HORSHAM DISTRICT COUNCIL CONSULTATION

TO:	Horsham District Council – Planning Dept
LOCATION:	Land Parcel at 519887 133300 Rusper Road Horsham West Sussex
DESCRIPTION:	Construction of Primary Road from the Left-In, Left-Out junction with the A264 (constructed pursuant to Outline Planning Permission DC/16/1677) to Bush Lane (Bridleway 1585), footpaths and cycleways, foul and surface water drainage including a SUDS basin and foul pumping station, landscaping, substations and associated infrastructure.
REFERENCE:	DC/25/1543
RE-CONSULT:	1 st set of comments in black 2 nd set of comments in blue
RECOMMENDATION:	Objection / Modification
SUMMARY OF COMMENTS & RECOMMENDATION: 2nd set of comments While some amendments, including smoother gradients in various locations, are acknowledged and welcomed, these are not in itself sufficient to address the fundamental concern expressed in regard to the proposed relationship of development with the existing landscape features. We respectfully request the evidence to demonstrate the applicant's response dated 15th Jan 2026, under no 7 <i>'The alignment of the road, and therefore the footpath and banking, are determined by the existing completed Li-Lo

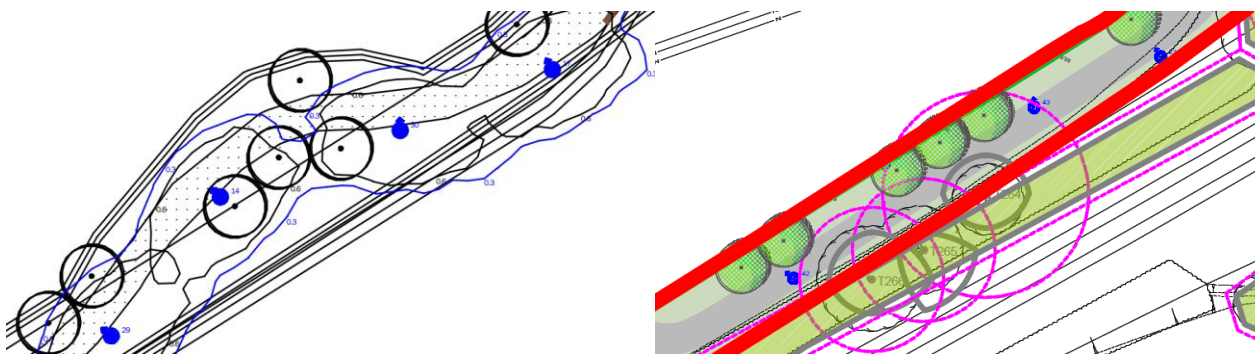
4. Given the undeveloped nature of the site, the RPAs must be entirely avoided in order to secure the retention and healthy conditions of key landscape features such as trees and hedgerows, as per the scheme's aims (see point 2). **Proposals must demonstrate compliance with BS 5837:2012 and as such, development within RPAs should only be observed where unavoidable. This fundamental principle of avoidance has not been demonstrated, and given the undeveloped nature of the site, we consider the layout can indeed be adjusted to fully avoid RPAs.**
5. As such, while the following examples adhere to minimum recommendations, the default position should be that development occurs outside of RPAs. We therefore request that footpaths and cycle paths are altered to avoid these areas. Please see examples below. **Not addressed**

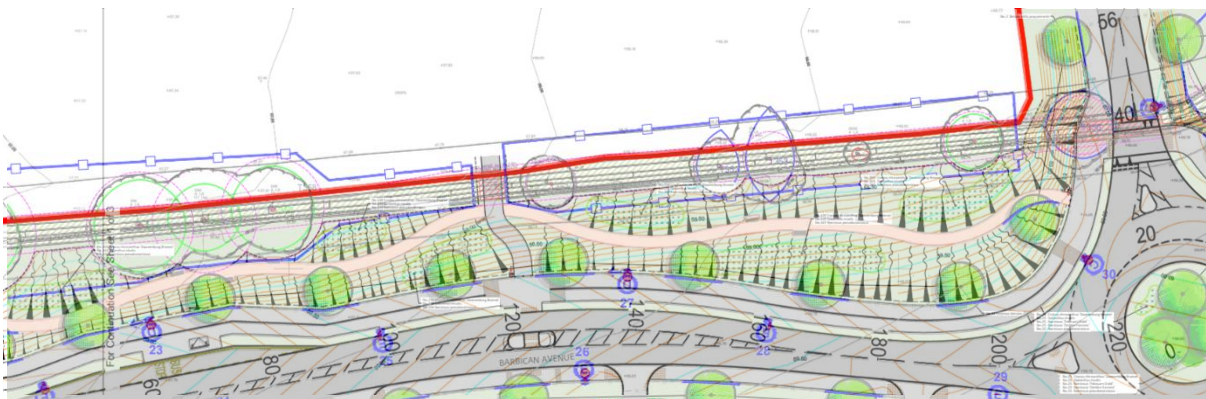
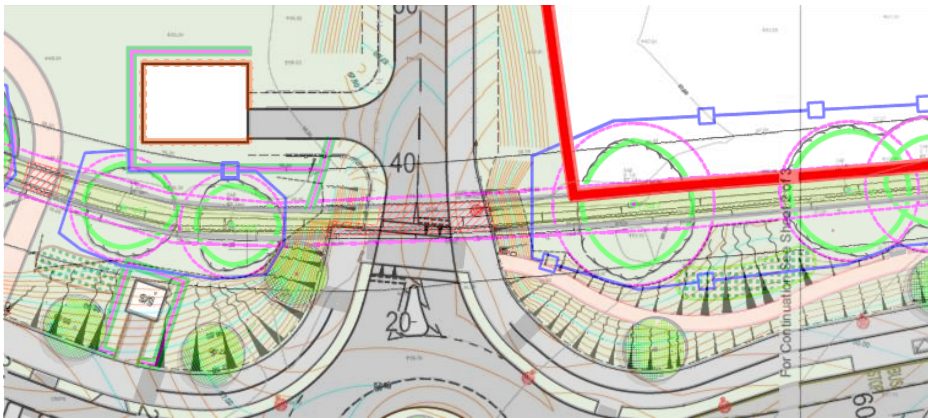
7. Partial clearance of category A mixed woodland group W281 is proposed under 5.15 of the AIA, however, it has not been included within the tree survey, nor labelled in plan. We

assume it is the area indicated below – if not please indicate the location of W281 in plan. [A2 category W281 added to the AIA and TPP, with thanks.](#)

Nevertheless, while the encroachment appears relatively minor, the deterioration of this existing vegetation would result in an eroding effect on the landscape character and as per points 2 and 4, its retention and healthy conditions should be secured from the outset. This arrangement is deemed an unnecessary undermining of green infrastructure and can be rectified by pulling the road, footpath and banking further south. [not addressed](#)

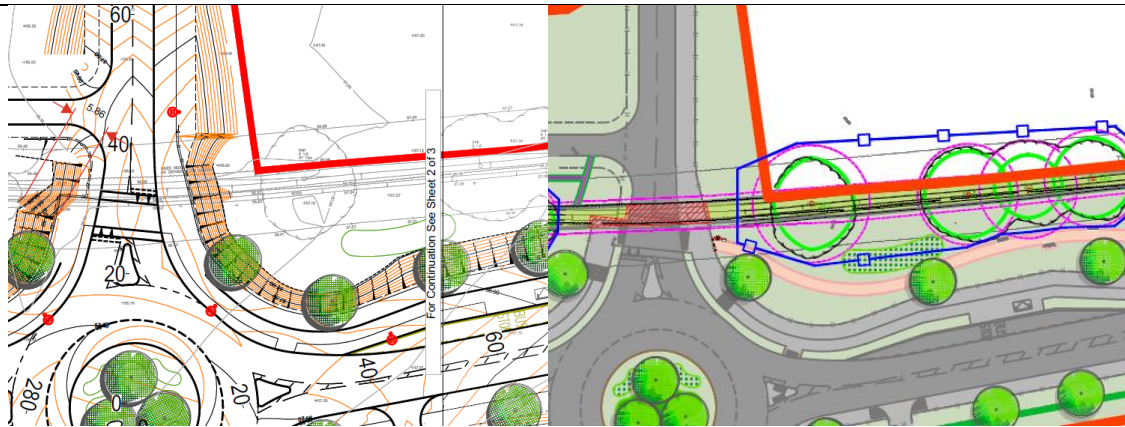
10. For example, while the road layout below is subject to a separate reserved matters application, major concern is raised in regard to the significant earthworks proposed within priority habitat woodland, which is reflected as retained within the TPP. As per points 2 and 4, this landscape feature must be avoided and thus we recommend reducing or removing changes to the topography.

[Some amendments are noted within this area, which includes the proposals of a retaining wall, presumably to reduce the impacts on the RPAs. However it is noted that while this is revised within the TPP, the levels plan remains unchanged as shown on the merged extract below:](#)

And further examples of proposed earthworks within the tree protection fencing area. We reiterate point 4 in regard to pushing the substation and hedgerow slightly north.

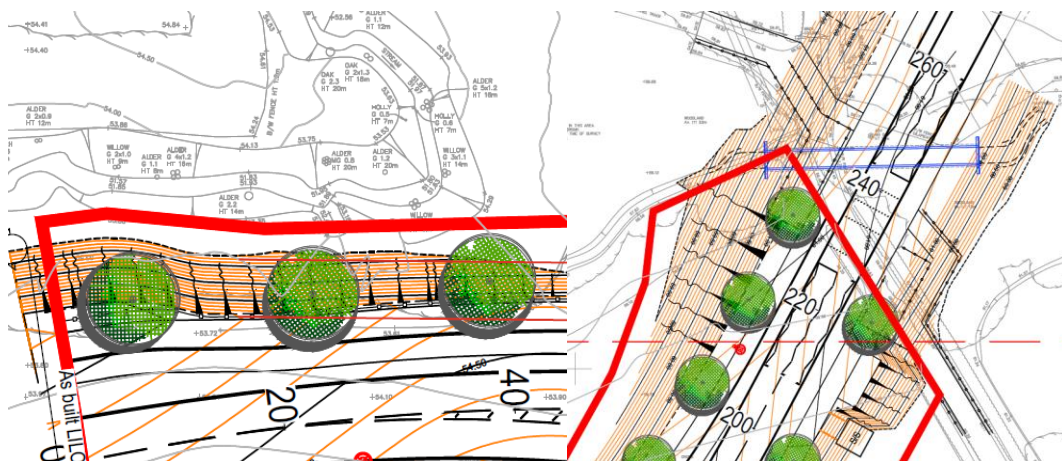
13. No drainage information has been submitted, however multiple drainage features are found within the red line boundary including the large attenuation basin and the 'selective tree removal for drainage trench agreed under Arboricultural Supervision within Mixed tree group G54 PA'. This information is requested. [Received - Closed](#)

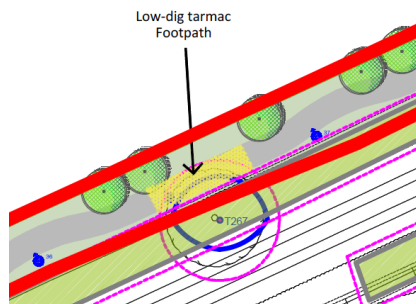
15. We note from the Landscape Statement under section 4.4 that the attenuation basin will be available as open space, however this is deemed unrealistic as the conditions are inappropriate for general amenity use. This is highlighted further by the proposed fence around the eastern perimeter. [Closed](#)

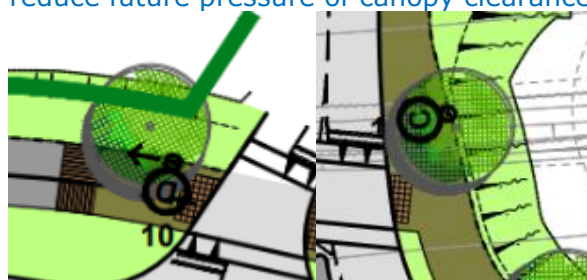
27. Woodland and hedgerows, which are key characteristics of the local landscape, can be deteriorated due to increasing levels of light pollution, therefore light spill must be considered sensitively so as not to cause potential adverse effects. The current lighting layout plan only indicates the southern cycle path. Please amend to reflect all lighting within the red line boundary. Street lighting layout plans received, with thanks. However, lux levels have not been indicated, thus light spill cannot be assessed. Please provide a lux levels plan for the entire red line boundary as opposed to just the southern cycle path.

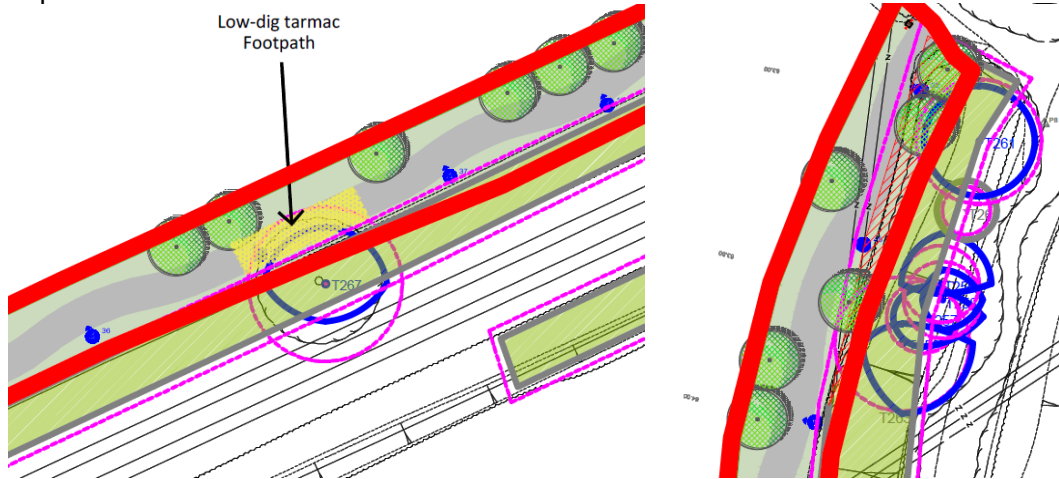
30. Please confirm if no lighting is proposed for the footpaths and cycle paths north of the main road. We note response dated 15th January which states that no lighting is proposed in this area. Closed, with thanks.
31. As per points 2 and 4, we recommend that utilities avoid RPAs where possible. As such, please consider slightly altering the locations of bollards and associated utility runs – see examples below. Not addressed
